**Subject: Comments on Lack of Demonstration of a Sustainable Water Supply,
Agenda Item 6.12 Board of Supervisors Meeting Tuesday July 14, 2026
Proposed Expansion of Pasta Farms 3 Cannabis Cultivation Operation, 10750
Siegler Springs Road, Kelseyville
Major Use Permit Application PL-26-115 and MND,**

I have been engaged by Adidam Holy Domains to review documents related to the proposed water supply for the proposed expansion of the Pasta Farms Cannabis Cultivation Operation.

Figure 2. Hydrographs Showing Water Levels in Project Wells 1 and 2

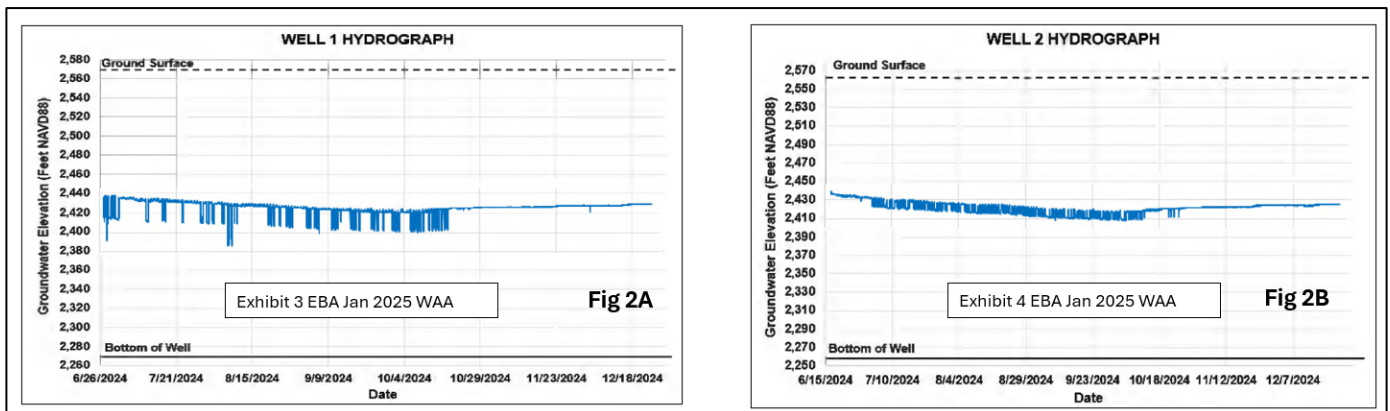
The Water Availability Analysis by EBA Engineering dated January 13, 2025 (EBA Jan 2025 WAA, Exhibit A5 to the Staff Report) includes water level hydrographs (Exhibit 3 and 4 on pages 21 and 22) that present monitoring data recorded in Project Wells 1 and 2 from late-June until mid-November 2024, which includes intermittent pumping for irrigation during the growing season. These two hydrographs are provided as **Figures 2A and 2B** below.

Unfortunately, the pumping rate data and/or total volume pumped with time at each of the two wells, which would facilitate analysis of the hydraulic properties of the fractured rock aquifer, are not provided. Nonetheless the monitoring data clearly document decreasing trends of water levels in the two wells and incomplete recovery to pre-pumping water levels when pumping is terminated after the irrigation season.

EBA states (Jan 2025 WAA, last bullet of the Conclusions Section, pg 23): “Groundwater elevations in Well 1 and Well 2 declined approximately 17 and 21 feet, respectively, from June through October, and gained back approximately 9 and 10 feet, respectively from October through December under non-pumping conditions.” Slightly different changes in groundwater level are estimated from the zoomed-in versions, which include a shorter duration of the data after pumping stopped. The estimates are provided for both versions in **Table 1**, below. Approximately 1month after pumping stopped, the recovery is 25% to 33% of the decrease in during the irrigation pumping period. And after an additional month without pumping, the recovery is approximately 50% of the decrease in during the irrigation pumping period. **In all cases the recovery is far less than 95% of the decrease during the period with pumping.**

Figure 3. Zoomed-In Hydrographs Showing Water Levels in Project Wells 1 and 2

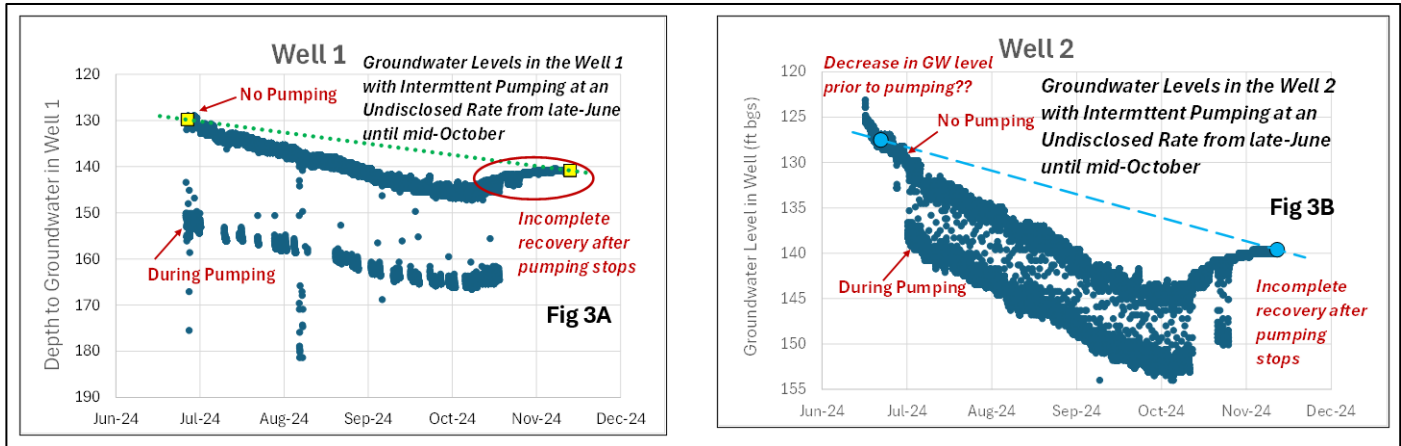
Figure 3A and 3B, below, are zoomed-in versions of the same water level data, which was provided by the Applicant, with annotations and trend lines, are inserted below.

The trend lines of the groundwater levels included on **Figures 3A and 3B**, above, which are fitted to the non-pumping water levels at the start and of the irrigation season and after ~one month of recovery when pumping was terminated, are extrapolated forward in time beyond June 2028 on **Figure 4**, below. Assuming similar pumping each irrigation season, **the extrapolated linear trends show groundwater levels dropping below the top of the well screens in Well 1 and Well 2 in 2028 and 2026, respectively.** As the groundwater levels drop below the top of the well screens, the yields of the wells are likely to decrease, and the groundwater levels are likely to drop more quickly.

Figure 4. Extrapolated trendlines of groundwater levels recorded in Wells 1 and 2 during 2024 (see Figure 2A and 2B, above)

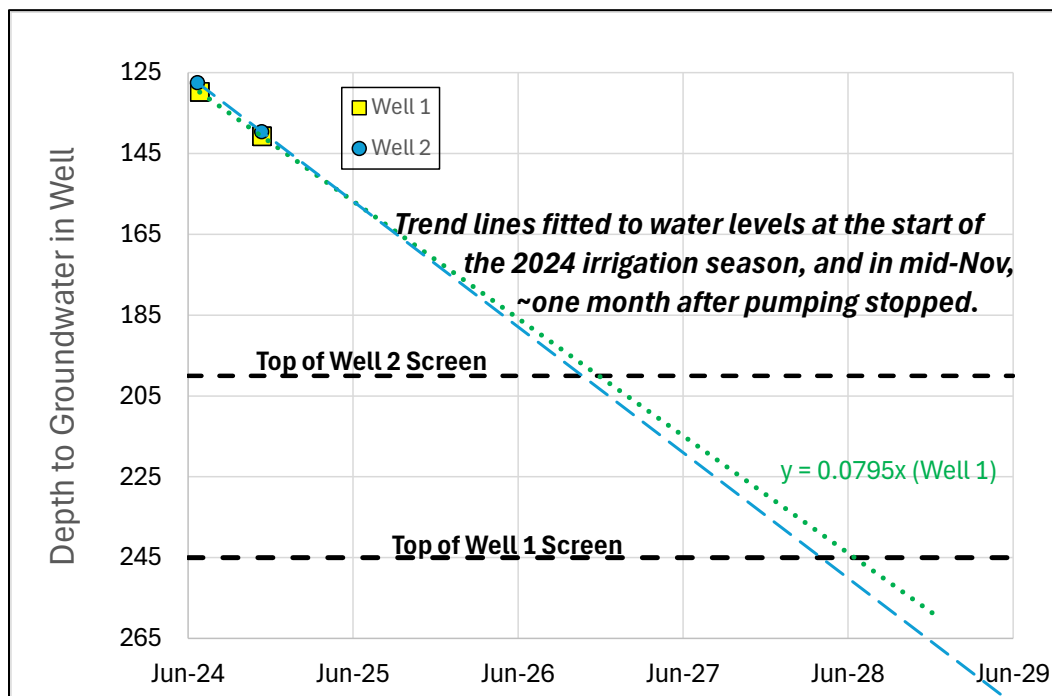
Additional water level data for Wells 1 and 2, such as for 2025 would be helpful and facilitate refinement of this analysis. Also, operational data from other wells that have been used during several previous years of operation of the Pasta Farms Facility would be helpful.

Figure 5. Well Density Map

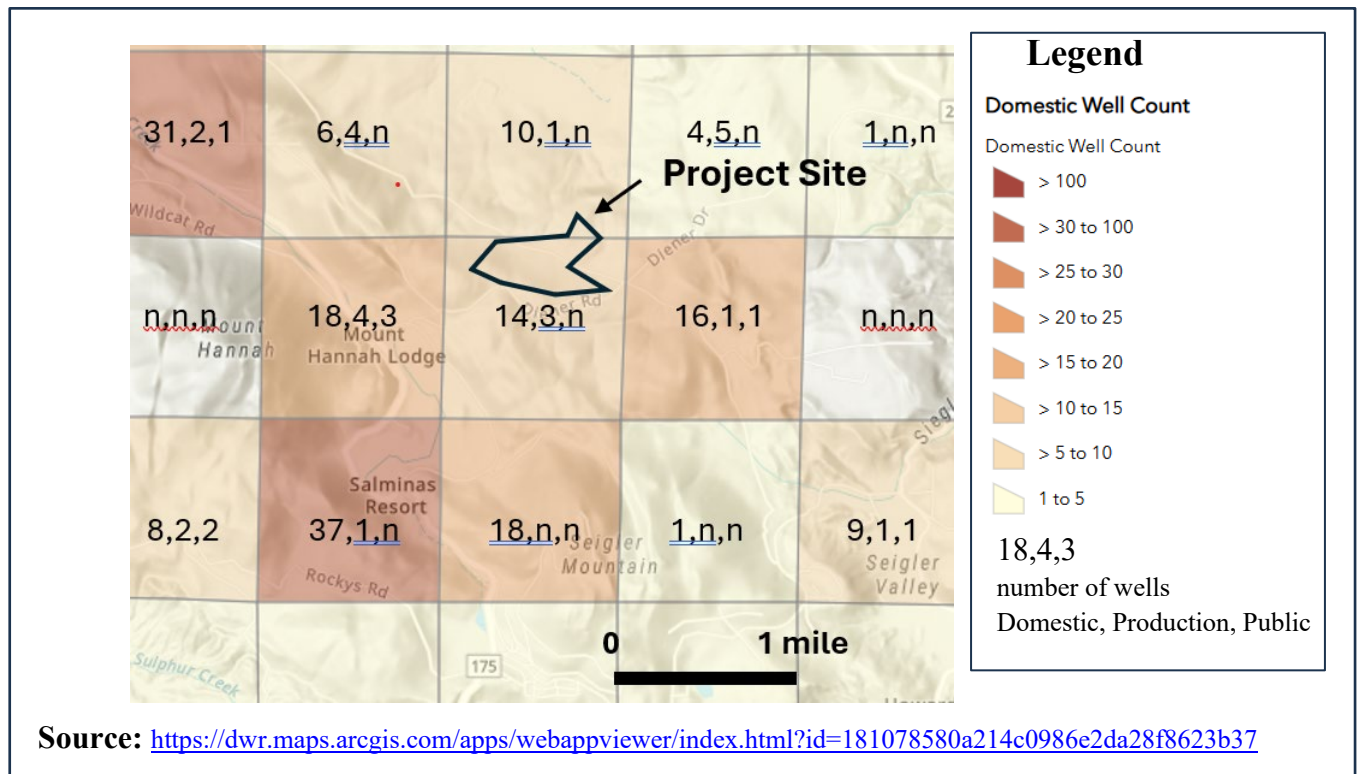
Most importantly, the calculation of extent of influence of pumping is based on only 515 minutes (8.6 hours) of pumping, which would be the daily duration of pumping from the two project wells to meet the maximum daily demand during the irrigation season. Accordingly, as stated on page 20 of the EBA Jan 2025 WAA, **“the analysis assumes 95 percent recharge [recovery] in the respective wells before initiating the next pumping cycle.” But, as clearly documented by the water level monitoring data presented above, this assumption is not valid.** The cumulative influence of pumping cycles and potential impacts to the numerous wells in the general area must be considered. **Figure 4**, below, shows well densities in square mile sections in the vicinity of the Project Site.
